COTTAGE GROVE PLANNING COMMISSION

February 24, 2025

STAFF REPORT CASE: CUP2025-007

Planning Staff Report

SITE CIRCULATION PLAN		CONVENIENCE STORE 1739		COTTAGE GROVE, MINNESOTA	
NO.	DATE	DESCRIPTION			
-	24JAN25	INTERNAL REVIEW			
-	18FEB25	CITY COMMENTS			
DRAWN BY					
SCALE				GRAPHIC	
PROJ. NO.				24-1739	
DATE				XXXXXXXX	
SHEET				C180

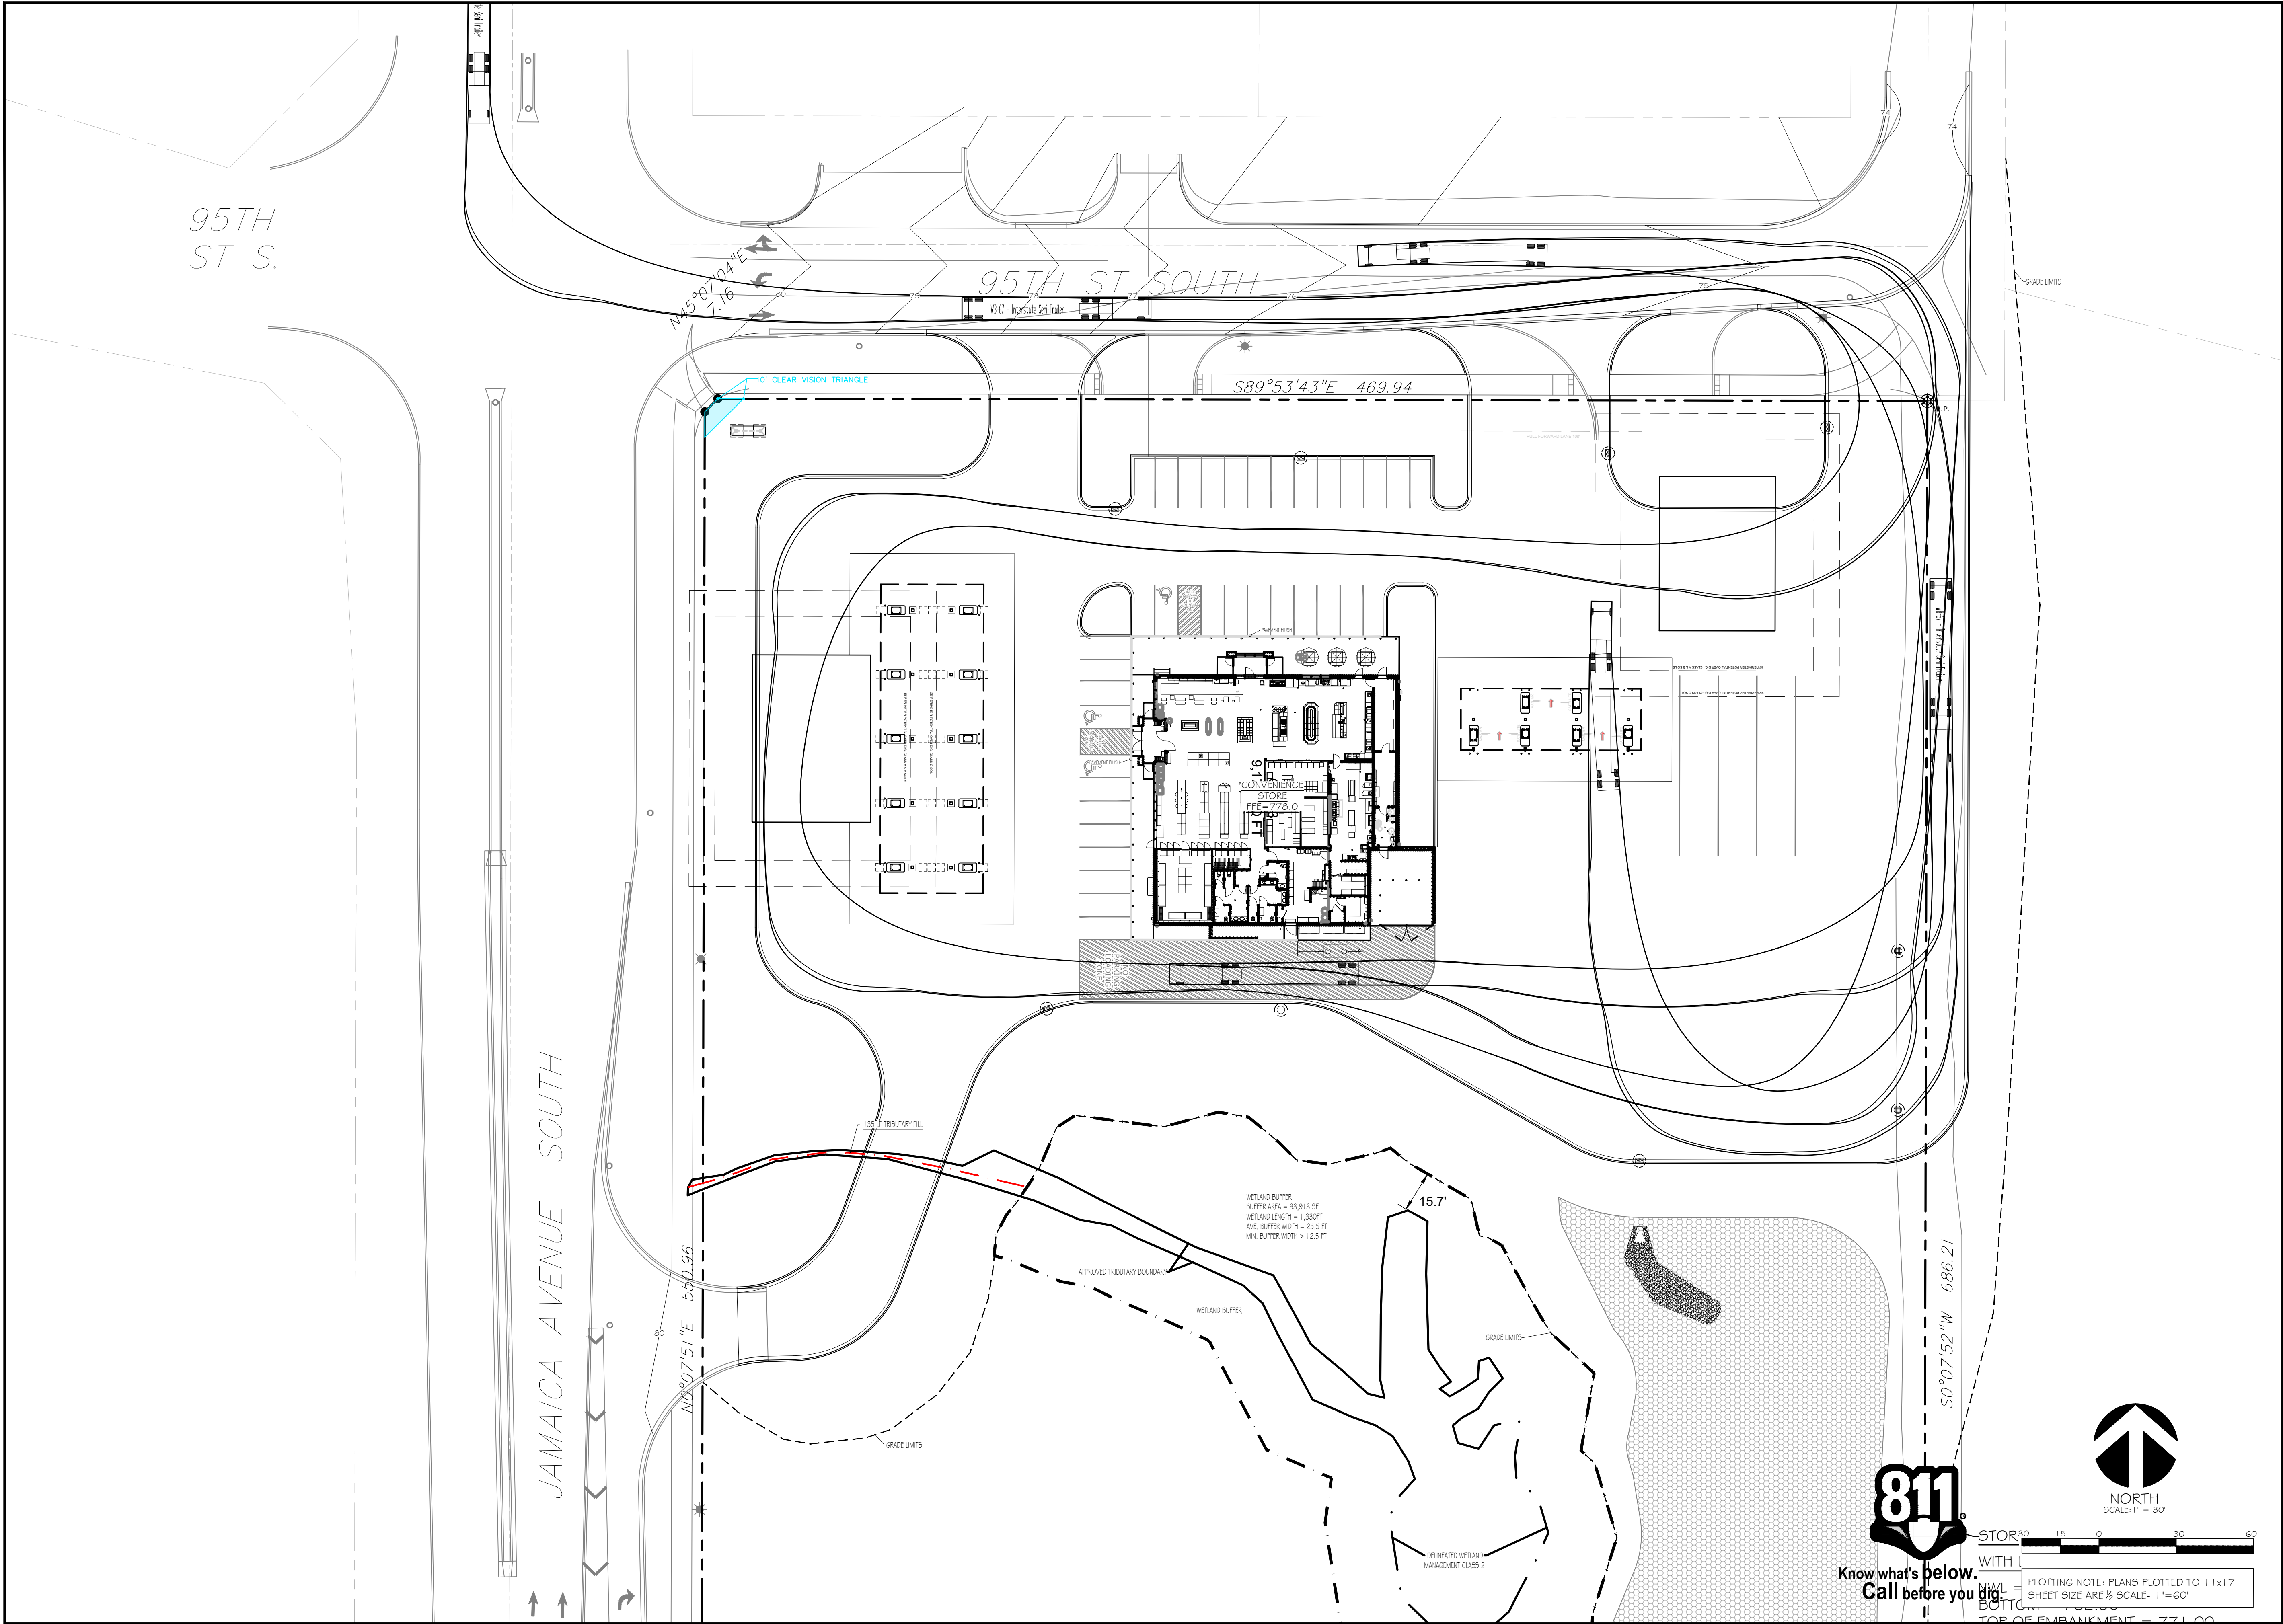
Sheet C180:

LANDSCAPE PLAN

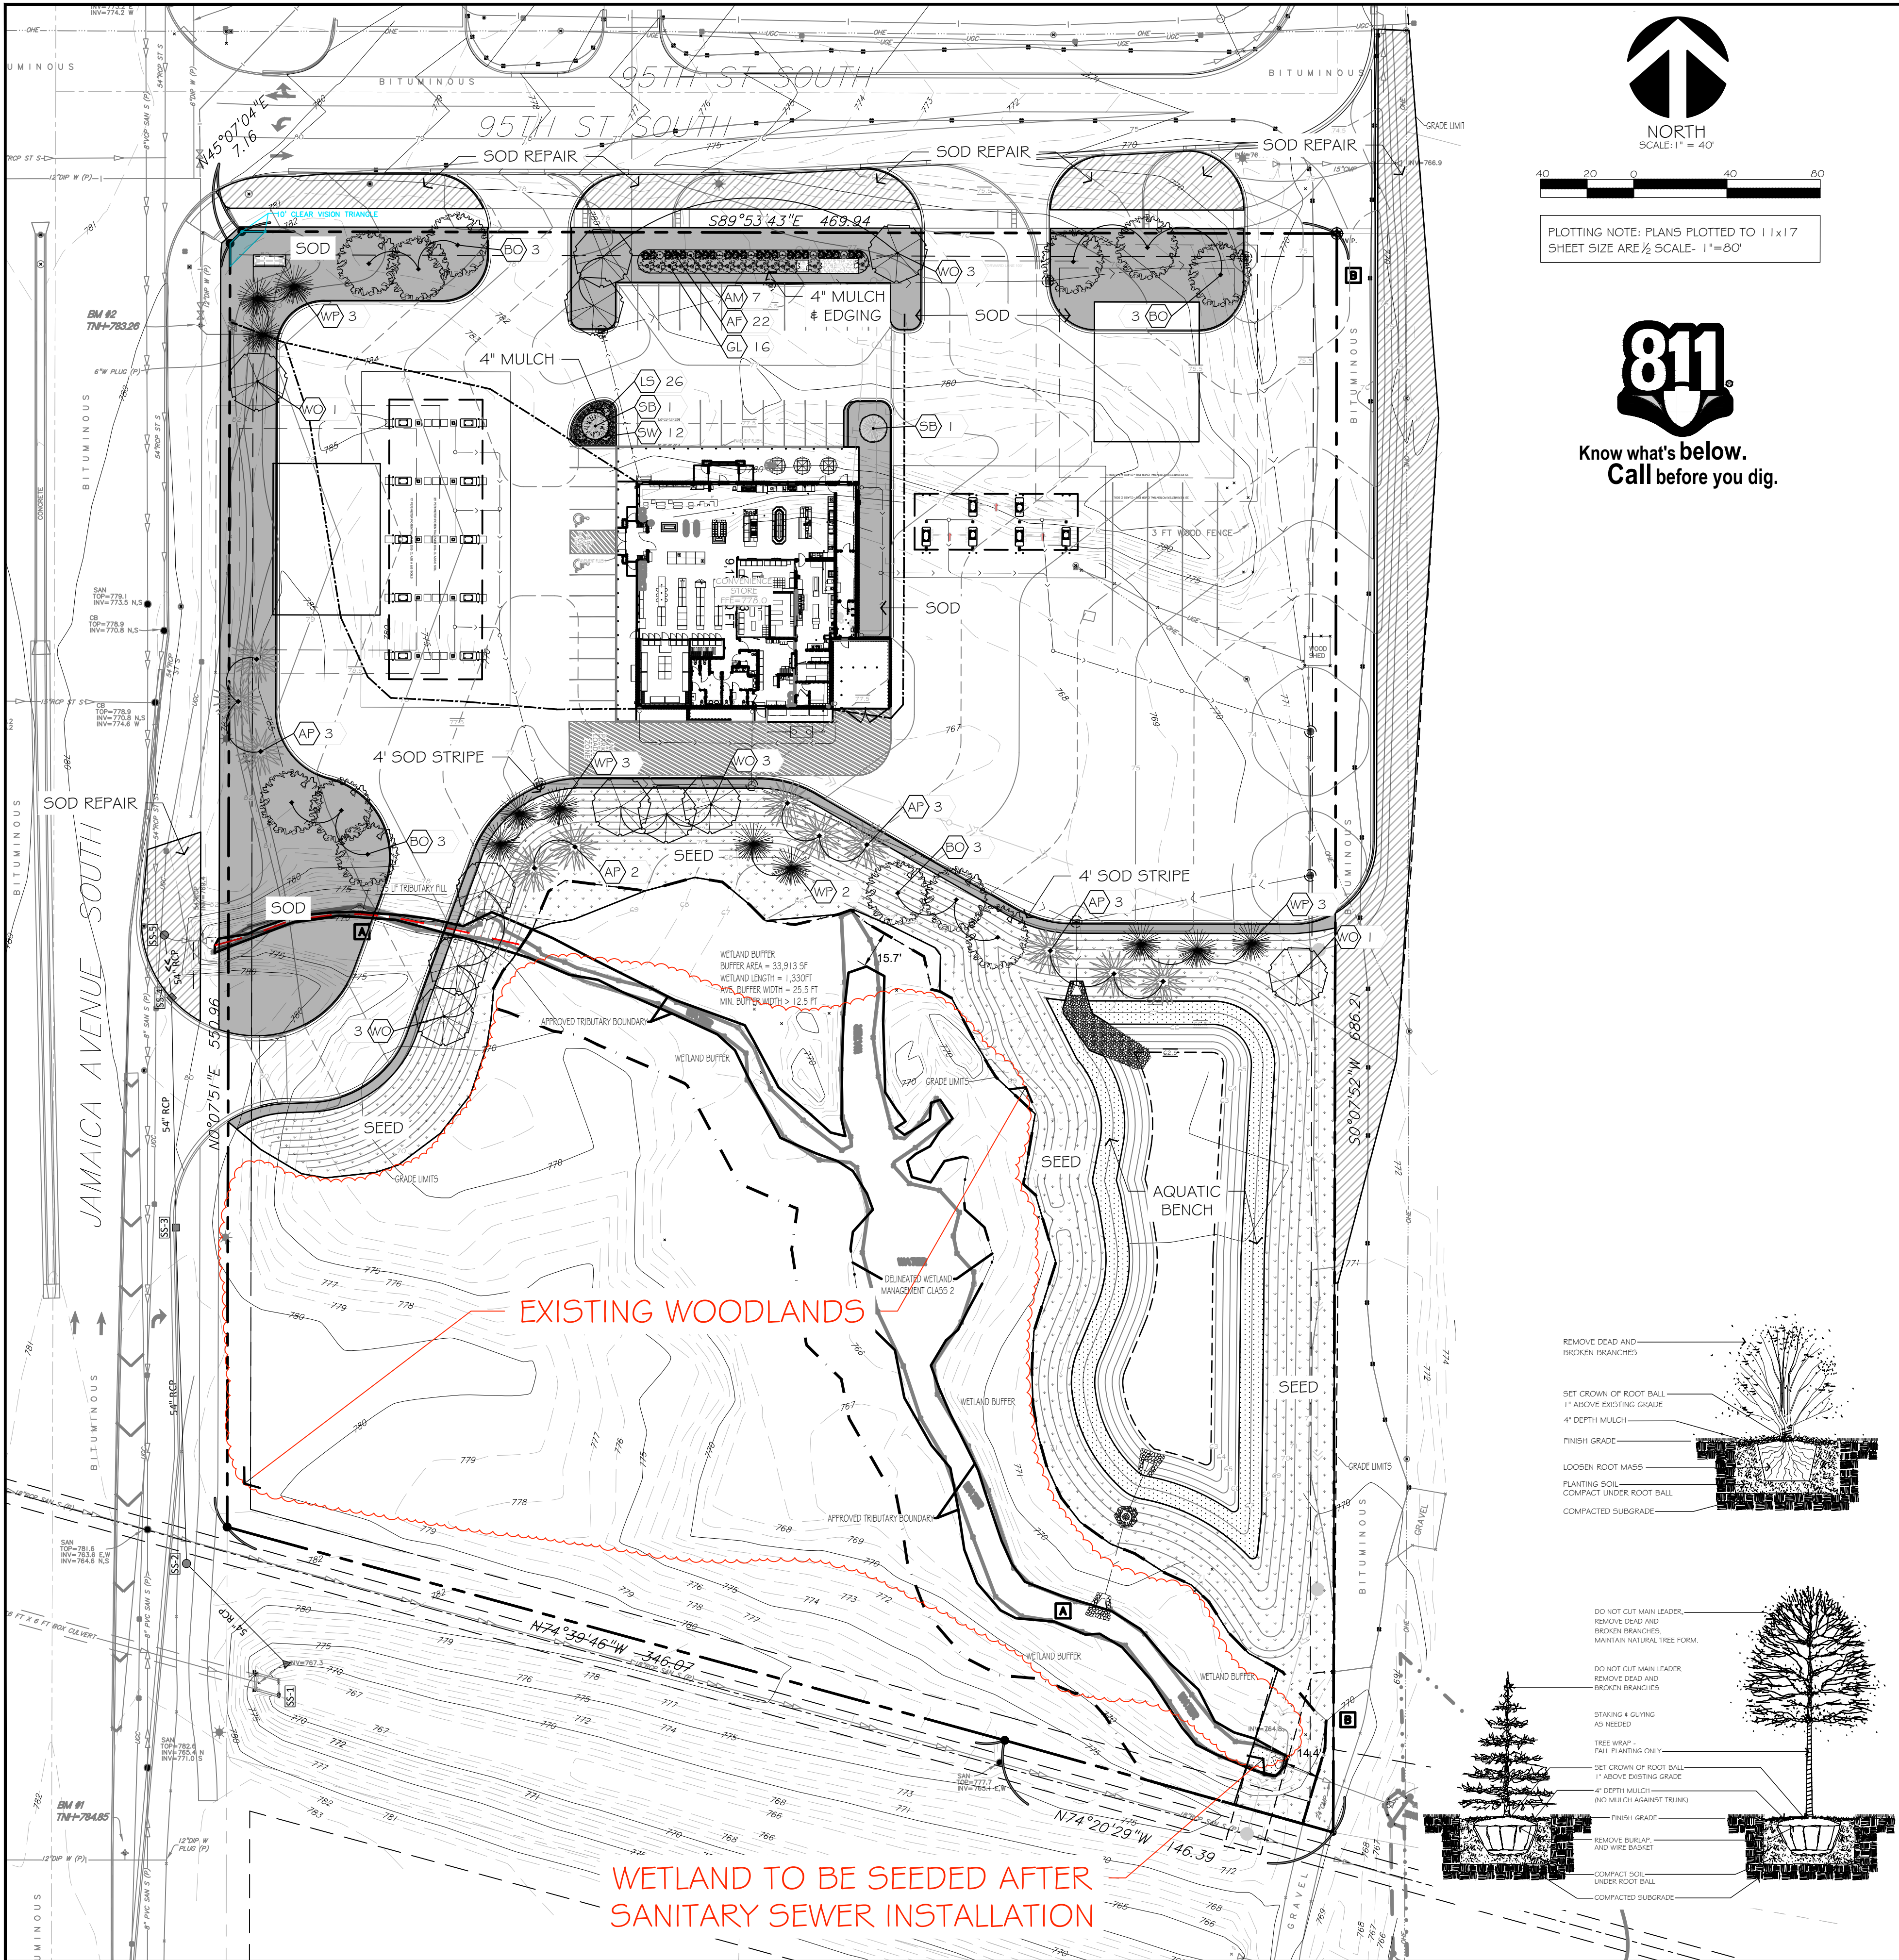
27. Restoration:
 - a. 95th Street right-of-way depicts "seed repair" in the boulevard. This is in conflict with the following:
 - i. The notes on Sheet C700 indicate that the "contractor is responsible for sodding all areas disturbed by construction including all R.O.W."
 - ii. General note #28 on Sheet C401 indicates sod in right-of-way.
 - iii. Therefore, both the 95th Street and Jamaica Avenue right-of-way adjacent to the parcel shall receive sod and irrigation.
 - b. All turf areas within the site shall also be sodded.
 - c. The solid hatch depicted in plan view does not appear in the legend.
 - d. Native Seed Mix: Pond side slopes above the NWL should include a native seed mix. Please consider use of a Native Seed Mix such as 33-261 Stormwater South & West or explain why this is not appropriate.
